Attachment B1

Selected Drawings

PROJECT
2235 BILLYARD 21C
DRAWN SENIOR QA APP'D
MP CM WS

DWG TITLE
LEGEND, DRAWING LIST, SITE MAP
DWG NO REV
DA000 J

1 O-B08

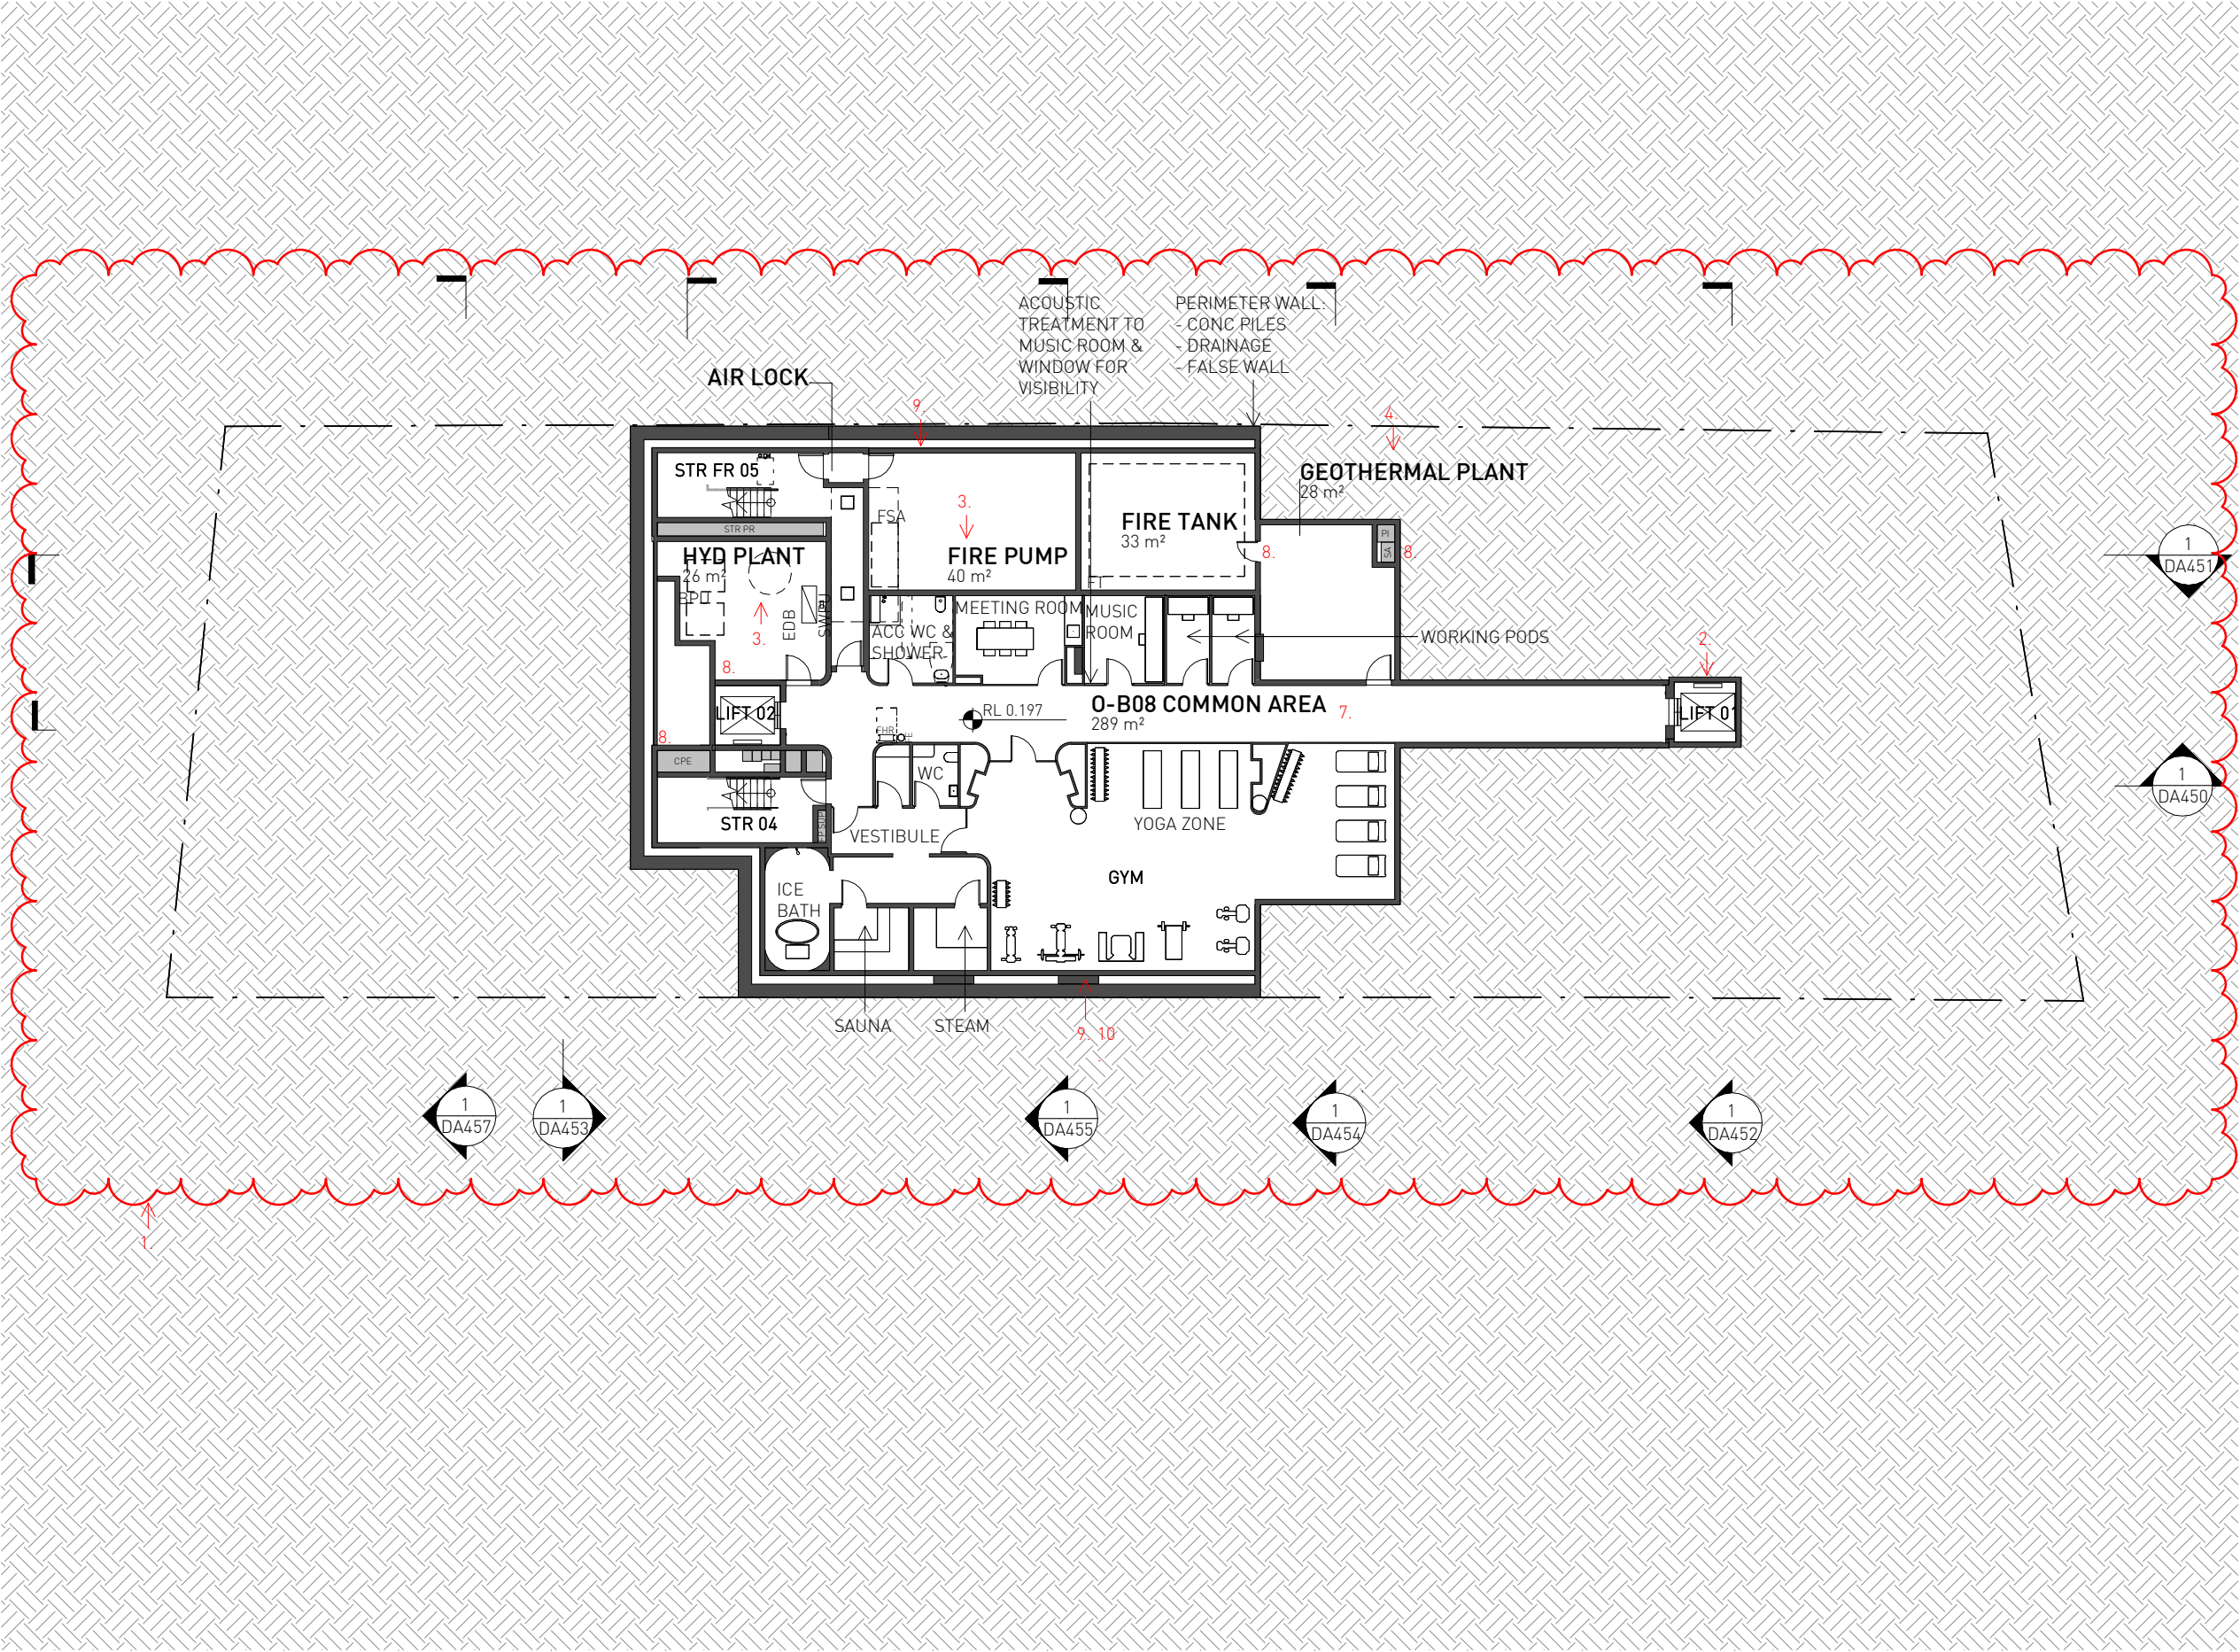
- 1. O B08 level added for internal common area.
- 2. Lift 01 (Billyard building) extended to O B08 level.
- 3. Fire tank & pump room & hydraulic plant relocated to O B08 level.
- 4. Geothermal Plant added.
- 5. Wellness, gym, change / wc, meeting room & pods, music room added.
- 6. Acoustic treatment & window for visibility to be provided in music room.

- DA ISSUE 07
- 7. Common area planning updated.
 - 8. Services & Plant areas adjusted.
 - 9. Structural elements adjusted.

- DA ISSUE 09
- 10. Detailing of services and structural elements shown.

1 O-B07 - B06

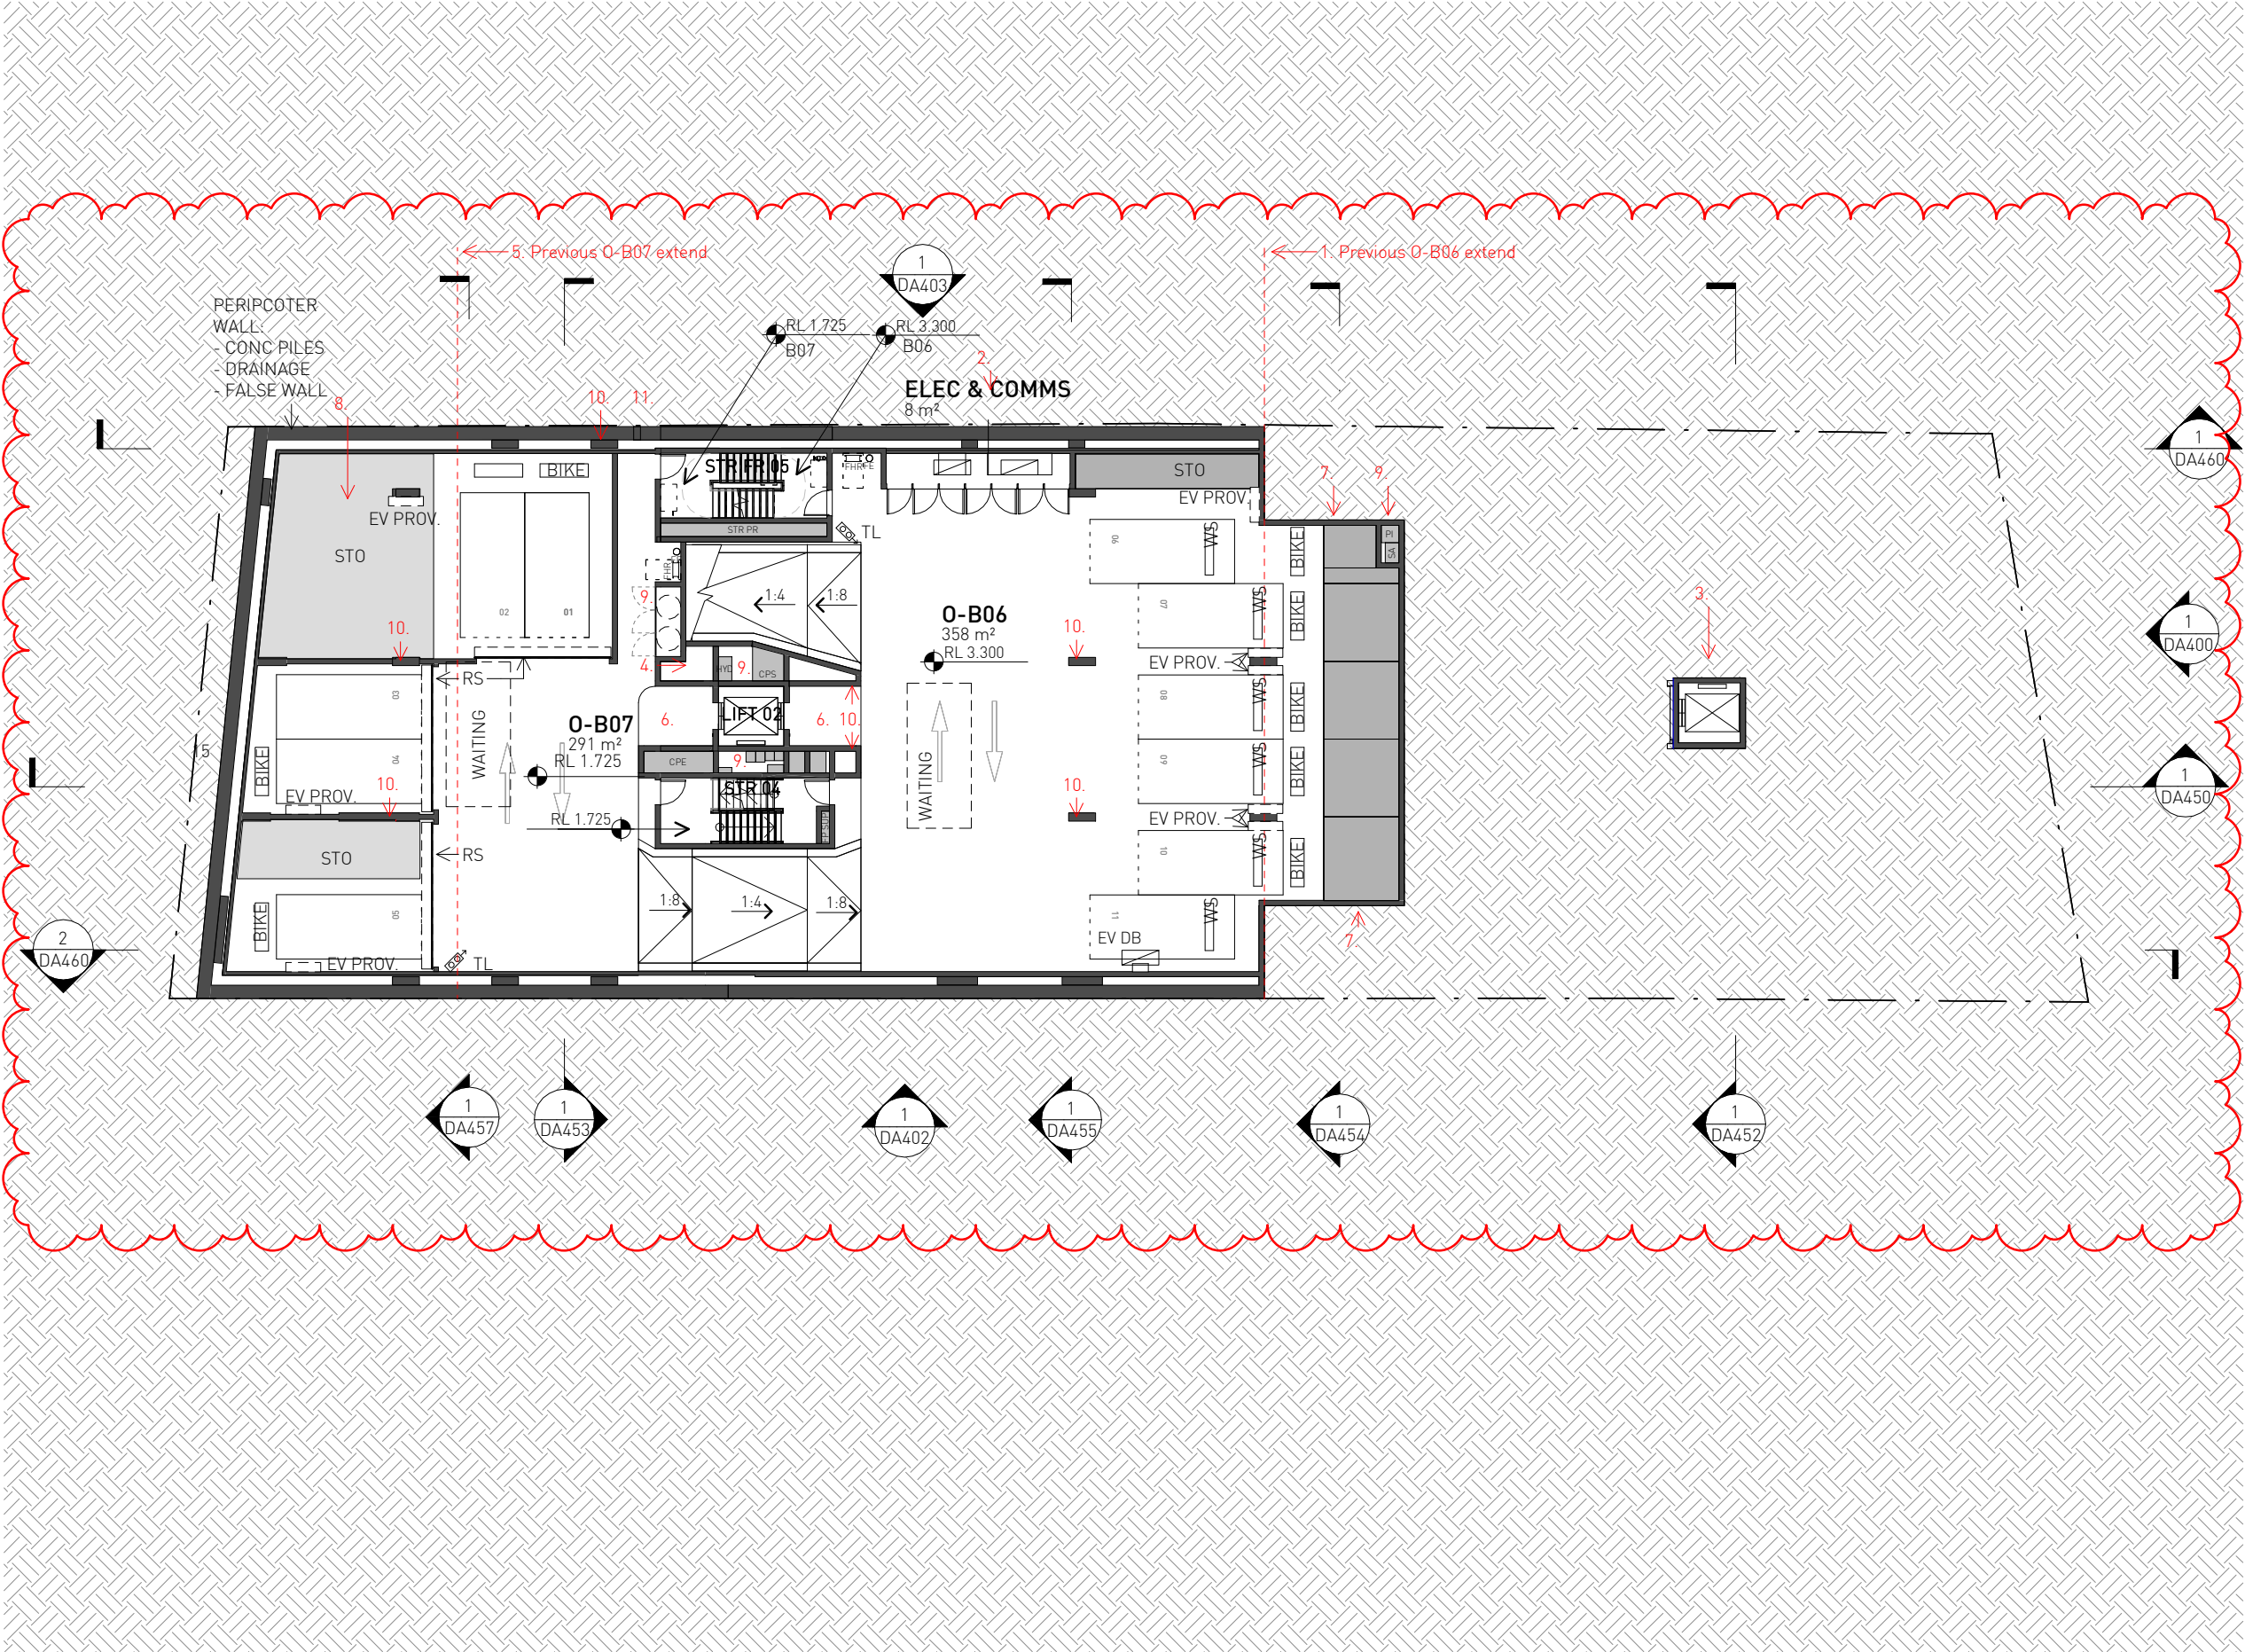
1. O-B06 basement extended.

2. Elec & Comms cabinet relocated.

3. Lift 01 (Billyard building) extended to O-B08 level.

4. Waste chute removed.

5. O-B07 basement extended.

6. Carpark EXH fans relocated from roof to CP lobby ceiling areas.

7. Basement extend changed to provide more deep soil.

8. Storage added to garages.
- DA ISSUE 07

9. Services areas adjusted.

10. Structural elements adjusted.

11. Detailing of services and structural elements shown.
